WLTP ROAD LOAD IMPROVEMENTS

IDENTIFIED AMBIGUITIES AND PROPOSALS TO RESOLVE

BMW, Lueglinger | 11.04.2017

IMPROVEMENTS IN FAMILY DEFINITIONS INTER AND EXTRAPOLATION

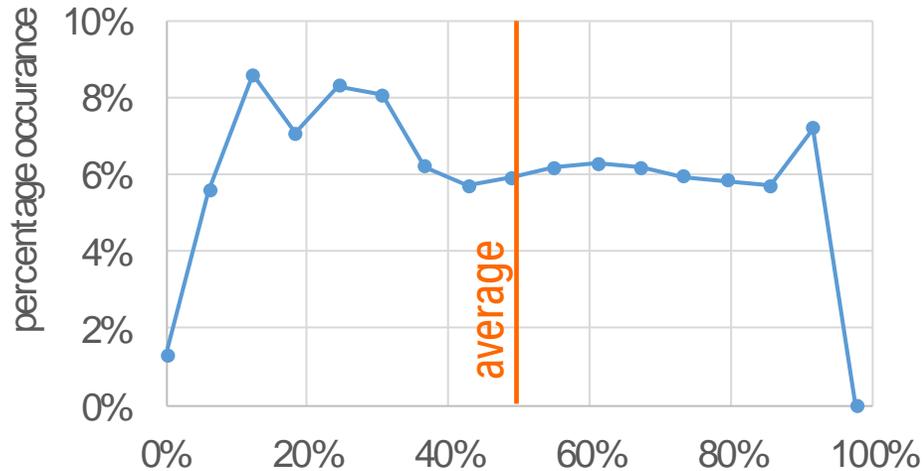
– How to apply the extrapolation is not clear enough. If there is a range of 27g tested, an extrapolation to the lower end is possible by 3g, but then no extrapolation to the higher end is allowed (max. 30g limit) – and the other way around. But if it is technically possible in each case, that restriction is obviously not reasonable. So maybe we should change that concept.

– In that context it appeared, that the 30g limit is often too small. There are validation data showing, that it works at least up to 40g. On the other hand we have already the concept of the mid vehicle for hybrid vehicles. So improvements are possible.

declared value	option
High 180 g/km	$180 + 3 = 183$
Low 153 g/km	$153 - 3 = 150$
new: $\leq 27g$ demand	no further limit ($<33g$ indirectly)

As this is very fundamental, it cannot be handled as a short proposal to be resolved quickly.
If it is generally supported to develop that two issues, more detailed proposals will be prepared.

IMPROVEMENTS IN FAMILY DEFINITIONS DEFINITION OF MASS IN RUNNING ORDER

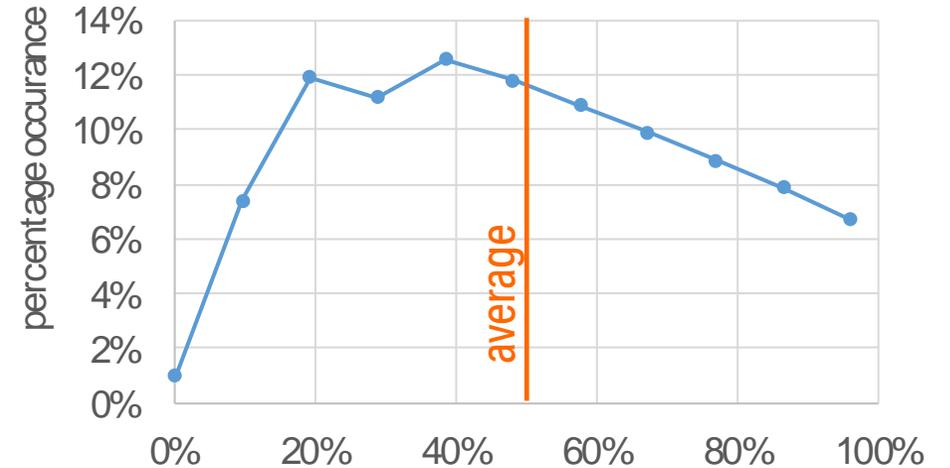
Graph show data from 2 different vehicles.
Data show 47% average for sedan, 50% for the compact vehicle.

- Current definition requires >90% liquids. That is not representative of real world situation.
- It is welcomed, to complement with independent data.
- **A value of ~55% for liquids seems more appropriate.**
